Change Order Bulletin

COB-26r

City and County of Denver | Department of Public Works Denver Central Library Renovations Interior Renovation Package

PROJECT DPL | Central Library Renovations
GoBond2018-043

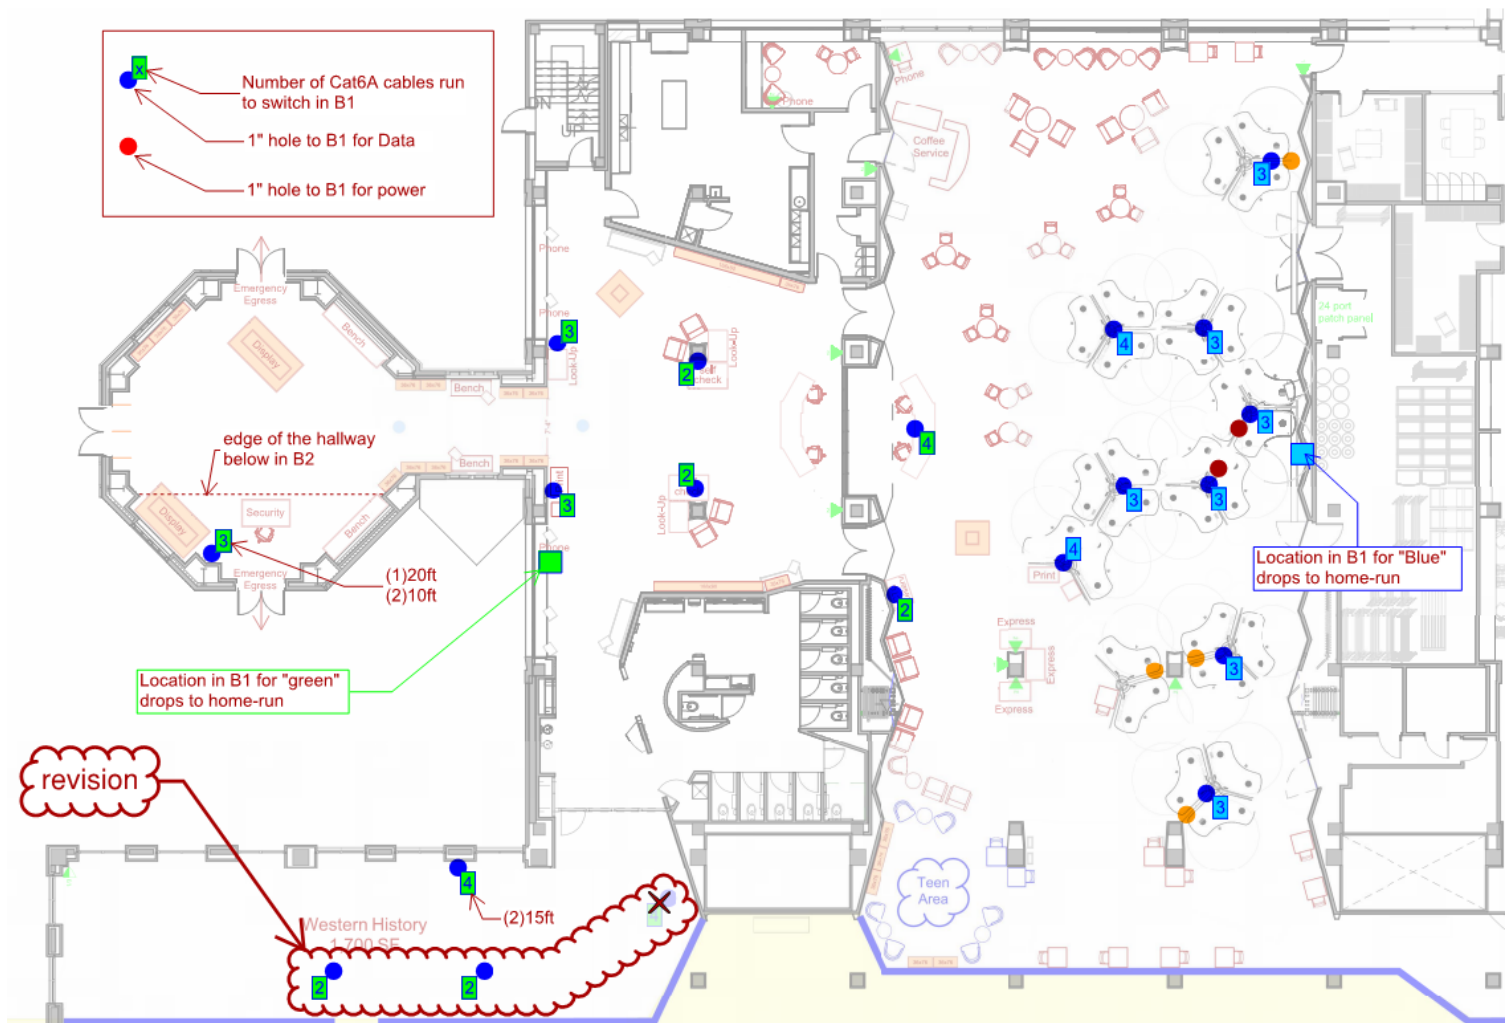
1. Provide temporary data (as shown on the following page) from two temporary switches located in B1 through the Level 1 floor into the Services Area in Pavilion, Pre-Function, LPS, and Temporary Western History areas.
 - a. Each Blue Dot on the attached plan represents a 1" dia hole drilled through the slab
 - b. Each 1" hole can accommodate up to four Cat6A cables
 - c. Provide the number of cables shown on the attached plan

- d. J-hooks and Velcro ties may be used at B1 ceiling to support cabling
- e. All Cat6A cables are to be terminated at the switch end (in B1) and landed
- f. Provide 6 feet of excess cable at each dropped location, unless noted otherwise
- g. Terminate cables with RJ45 and coil cable on the floor at each drop location

2. Pull multi-mode Fiber Optic Cable from the B1 Telecom Room to the two remote switch locations in B1
3. Connect power to tri-plex computer desks. Maximum 8 computer stations per circuit. Pull power from spare circuits in nearest electrical panel in B1 to two locations marked on plan above with red dot.
 - a. Maximum 10 Desktop Computers per 15 amp circuit.
4. Provide grounded plugs to the ends of the whips at four tri-plex tables marked by orange dots.
